**Consultation Response on Transport for London plans to upgrade Cycle Superhighway 2 from Aldgate to Bow.****1. Introduction**

London Cycling Campaign welcomes the opportunity to comment on the plans to upgrade the cycling superhighway on the A11 trunk road from Aldgate to the Bow junction with the A12.

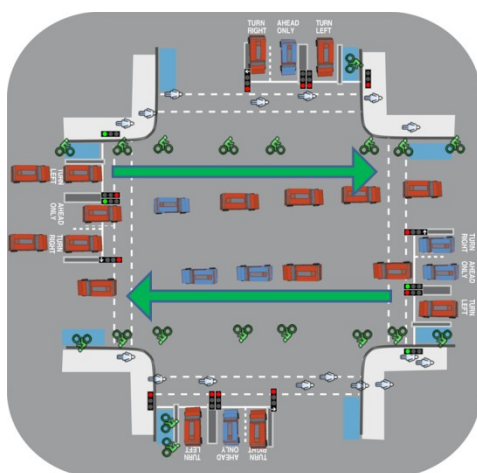
There are dozens of minor junctions where the failure to continue protected tracks up to the mouth of the junction effectively increases the turn radius encouraging faster left turns which put cyclists at risk. The junctions at Old Castle St. and Harley Grove are good examples of this problem. Every minor junction needs to be re-considered, to remove the risks of the effective widening of the junction mouth.

The design objectives for these junctions should minimise the gap in the segregated cycle route, have clear markings and a change of level so that motor traffic has to slow down and give way before entering or leaving the junction.

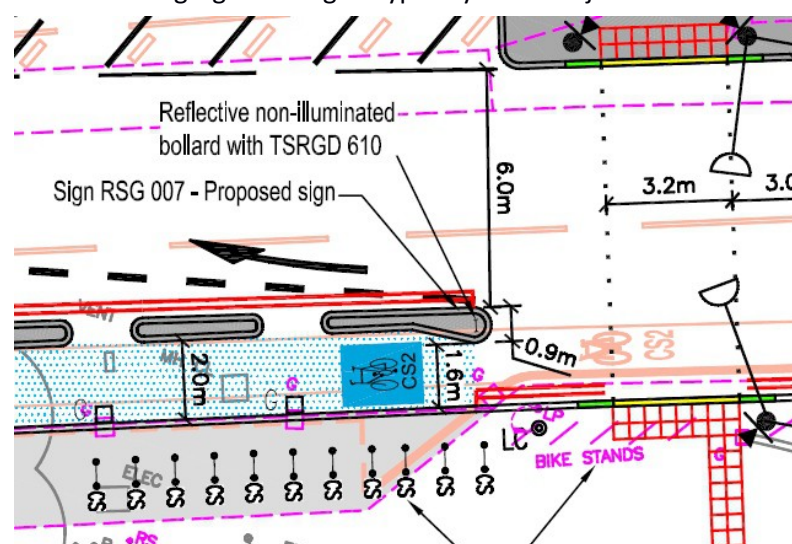
The Standard also notes how high kerbing, vertical upstands and proximity to other obstacles significantly reduce the effective width for cyclists. The current consultation gives very little information on the proposed cycle lane section but LCC is concerned that the design seen on the Stratford High Street of this route with high vertical upstands is not repeated. The risk of striking a pedal on high kerbs means that the effective width of the lane is reduced by about 300mm. An example of low upstands and battered kerbs being used to maximise effective width can be seen in Oxford St in the Oxford Circus area. The upstand between carriageway and footway is generally less than 50mm and the central median strip has battered kerbs throughout. Battered kerbs have angled faces at least 45° from vertical.

At about 20-30 points throughout the route the cycle lane width is reduced by 400mm where sections of segregation begin. Typically this is at junctions and occasionally after pedestrian

crossings. This repeated reduction to 1.6m in width is very hazardous, especially after junctions where there will be platoons of cyclists and a desire for overtaking. It appears that this reduction in width is to allow a bollard to be placed on the separating median strip. We note that this restriction has not been introduced on the CS2 section on Stratford High Street or on many other separated routes across London. It is unacceptable to

There is no need for more than 50mm vertical separation between the cycle track and footway, as is the norm in the Netherlands and Denmark. All the kerbing at the edge of the cycle lane should be battered. For most of its length the cycle lane should be at an intermediate height between the road and footway. Where the lane crosses minor junctions it should form part of the raised junction treatment with a very clear change of level from the roadway.
